SLIDING RINGS FOR WIDE-ANGLE JOINTS

COLOUR VARIATION DUE TO MATERIAL AVAILABILITY

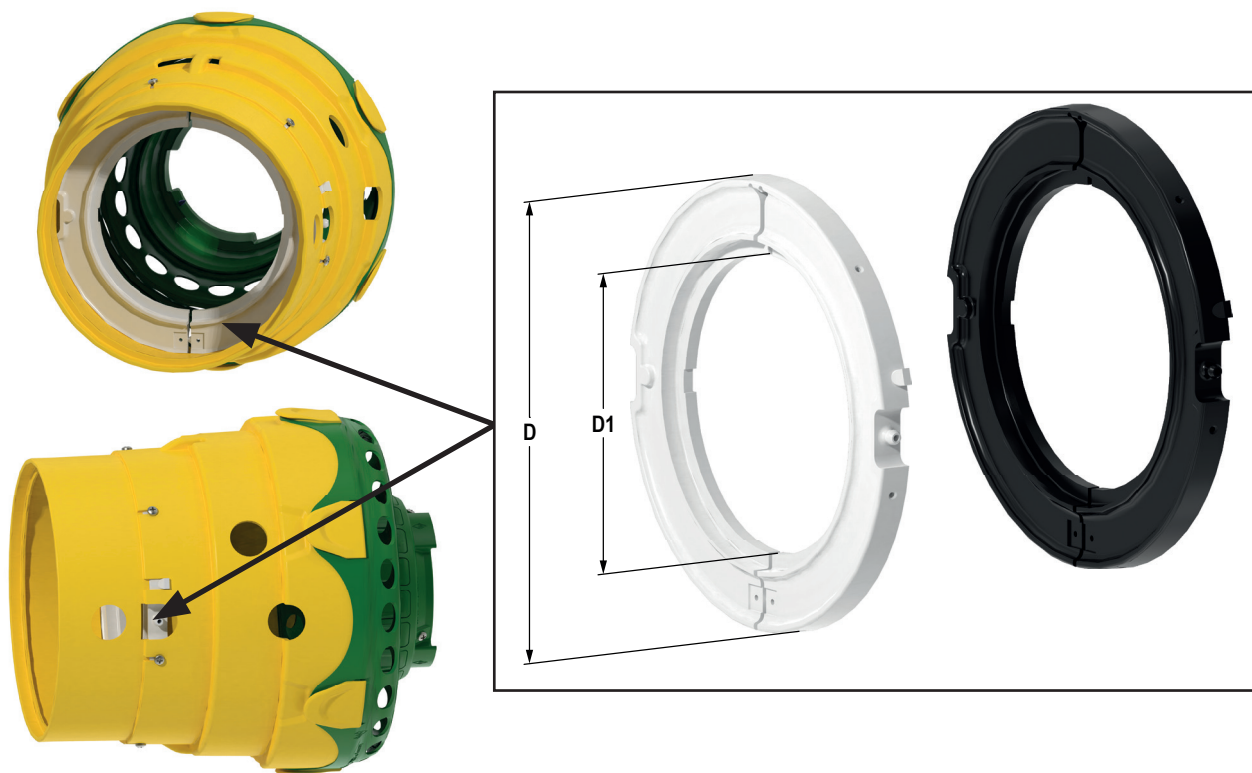
Due to material availability, additional, comparable materials for the sliding rings of Wide-angle joints were approved by corresponding tests according to standard EN 12965 and DIN EN ISO 5674. This can result in a shipment of white or black coloured sliding rings.
